Transportation Impact Study Cruz Landing & Maya Hill Subdivisions Knox County, Tennessee

Revised May 2023

PROJECT NAME: Cruz Landing and Maya Hills Subdivisions (6-SB-23-C & 6-SC-23-C)
TO: Knoxville-Knox County Planning
SUBJECT: Response Document for Cruz Landing and Maya Hills Subdivisions TIS Review Comments

Figure 3
Proposed Plan Layout
Cruz Landing & Maya Hills Subdivisions

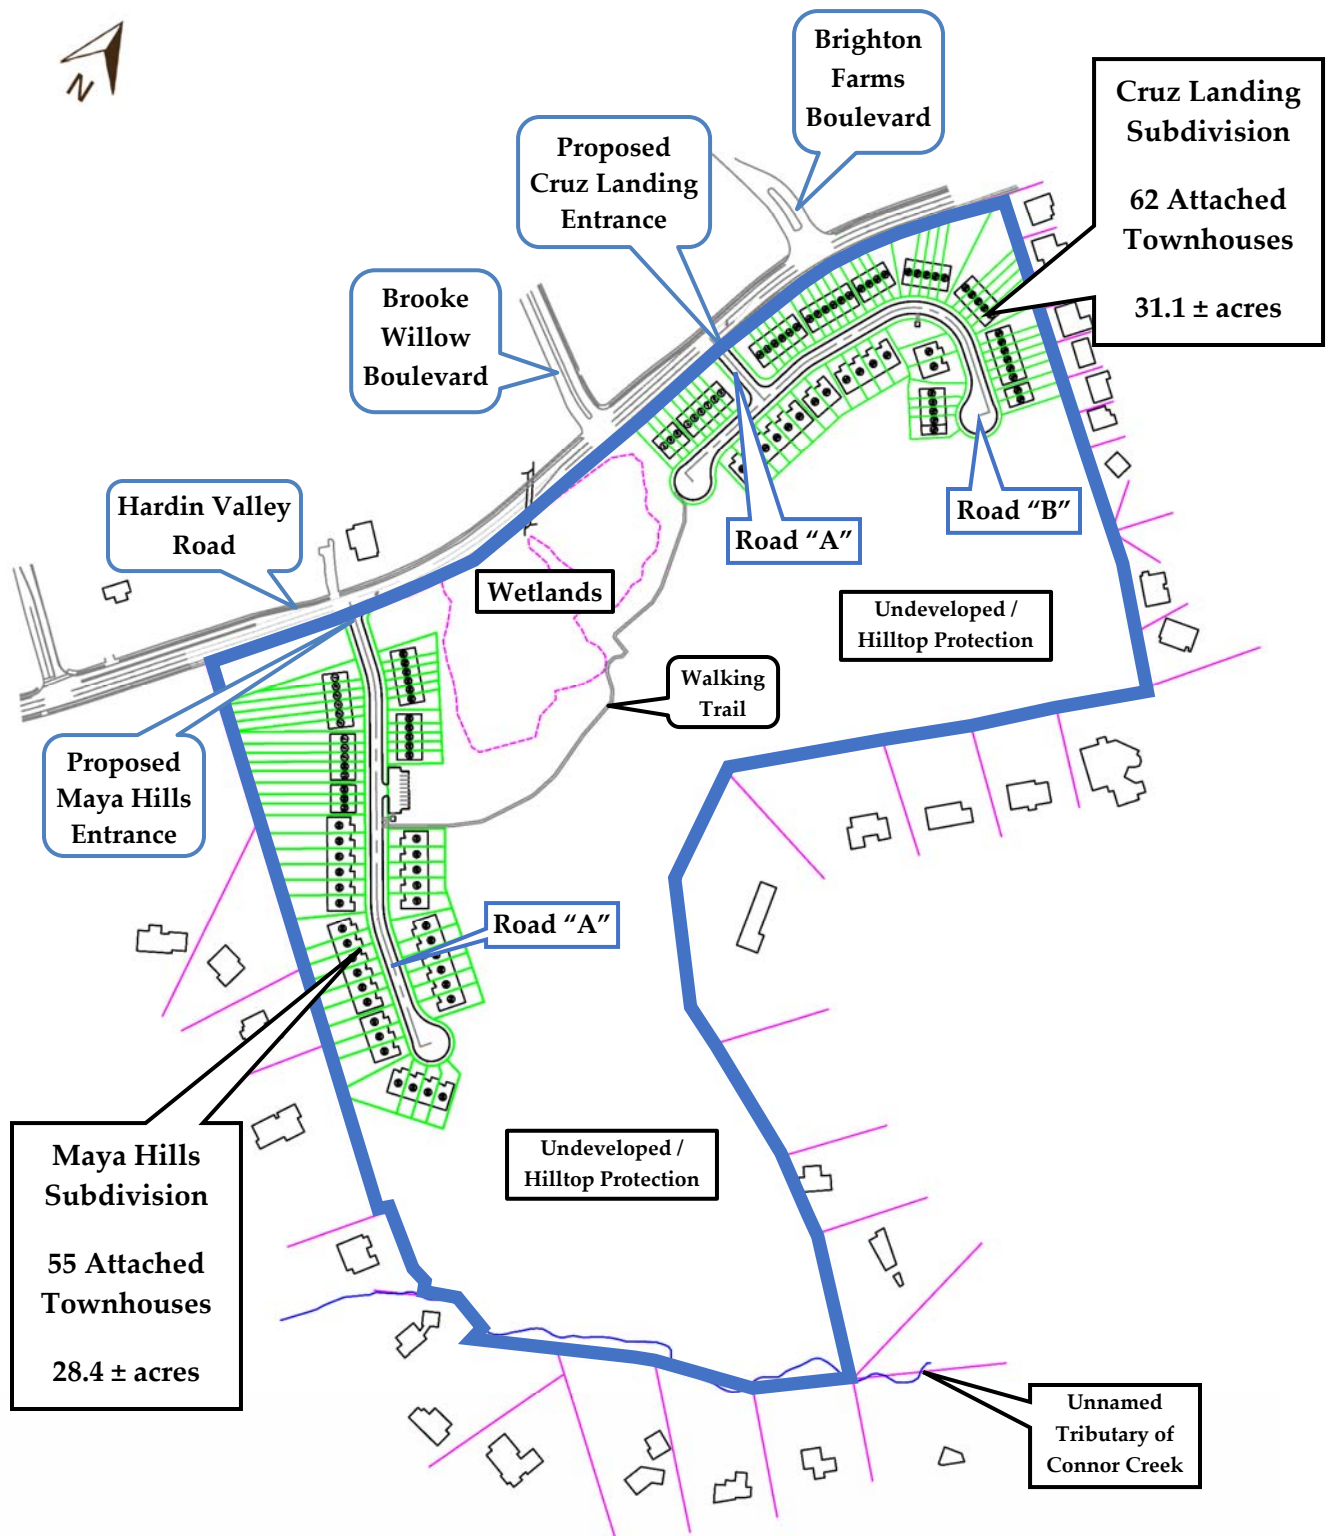
- 6. Knox County will be requesting the site plan be updated to include traditional cul-de-sacs for the interior streets instead of hammerhead turnarounds so please update any references in the TIS accordingly.**

Response: All references and recommendations for the original hammerhead turnarounds have been removed. The images of the hammerheads were removed from Figure 3 and other figures and references were removed from the document on Page 4, 2nd bullet point; Page 18, 1st paragraph; and on Page 57, recommendation 3a.

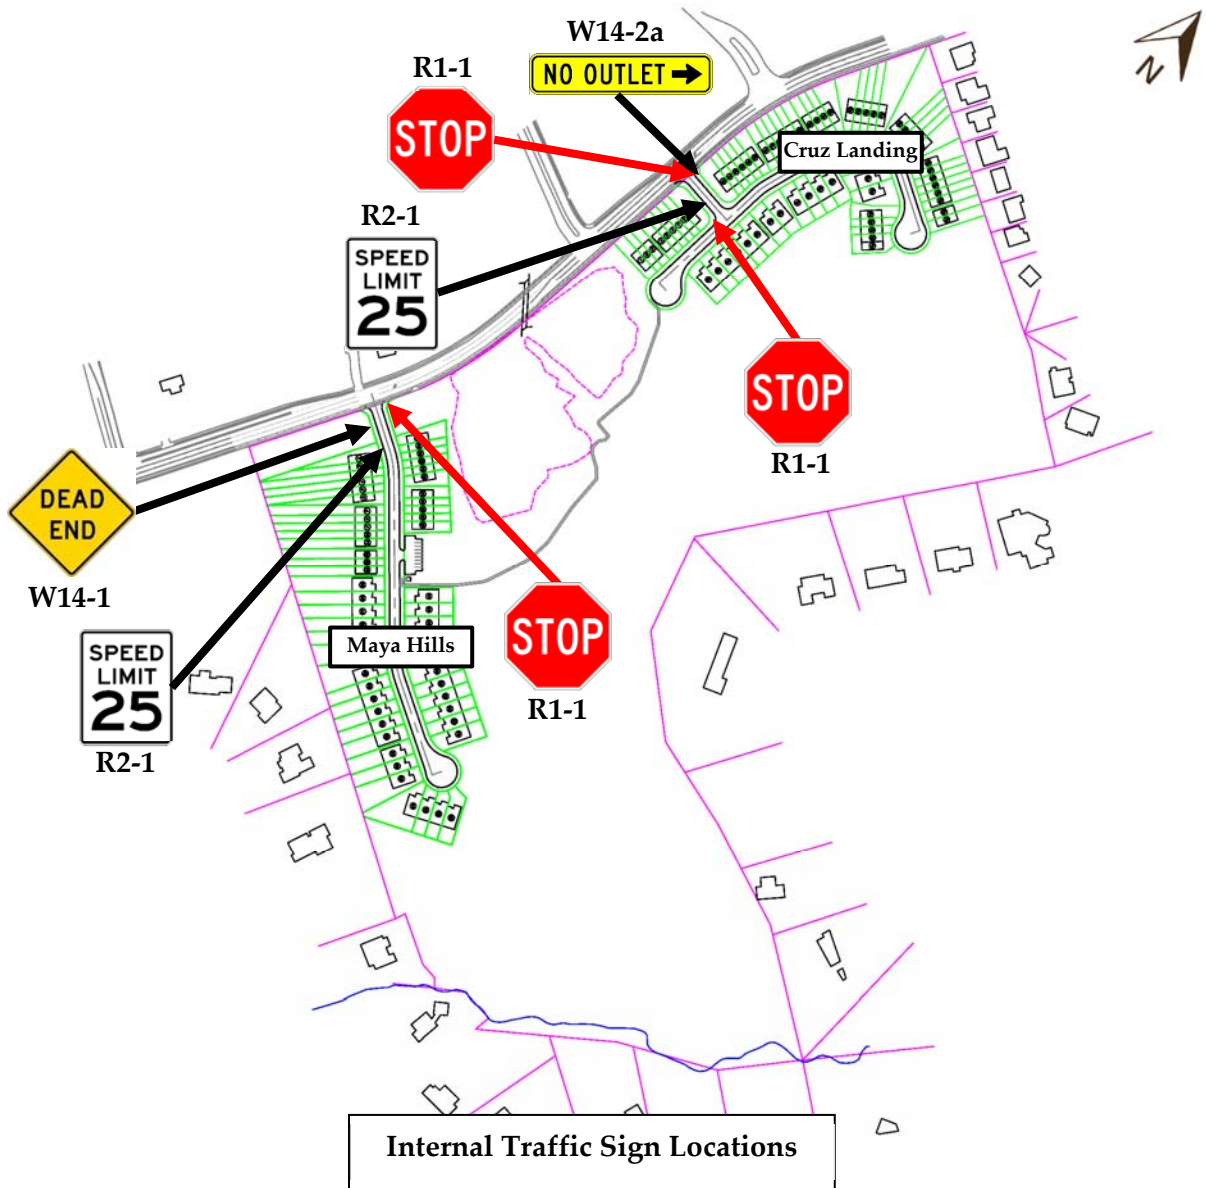
- 2. Additionally, and regardless of the left-turn lane scenario described in comment #1, there needs to be further description/graphics provided to show how everything ties back in to the west along Hardin Valley Rd since it appears as though some sort of transition/re-striping may be necessary where the existing school entrance westbound right turn lane develops in relation to the shifted through-lane geometry that will result near the Maya Hills entrance location. Please also coordinate with the civil engineer to depict the appropriate laneage/stripping pattern on a set of updated site plans for our review that also shows locations of access points/public streets on the north side of Hardin Valley Rd for better context.**

Response: The proposed layout of the pavement striping on Hardin Valley Road is shown in an image at the bottom of Page 55 and is discussed in recommendation 2a on the same page.
